REMARKS

Amendment Under 37 C.F.R. § 1.116
U.S. Application No.: 10/058,804

Attorney Docket No.: Q68166

Fig. 1

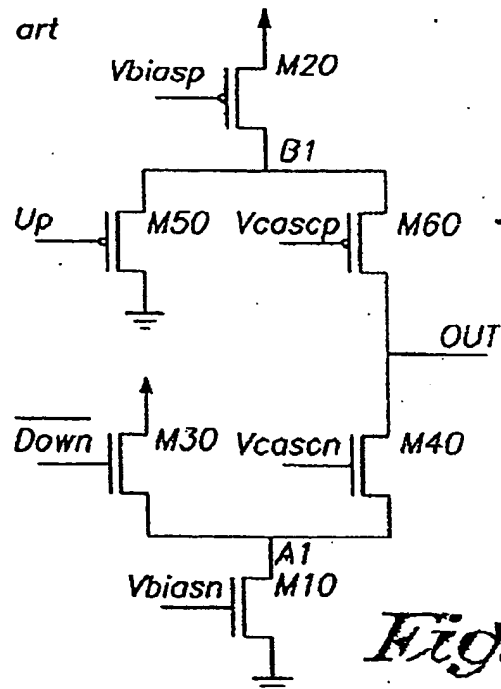
The Examiner objects to the drawings, asserting that Figure 1 should be labeled Prior Art. It is respectfully pointed out that Figure 1 filed on January 30, 2002, was labeled "Prior Art" as shown in the copy of the Drawings filed on January 30, 2002, which the Examiner will find attached. Accordingly, the Examiner is kindly requested to withdraw the objection and approve the formal drawings filed on January 30, 2002.
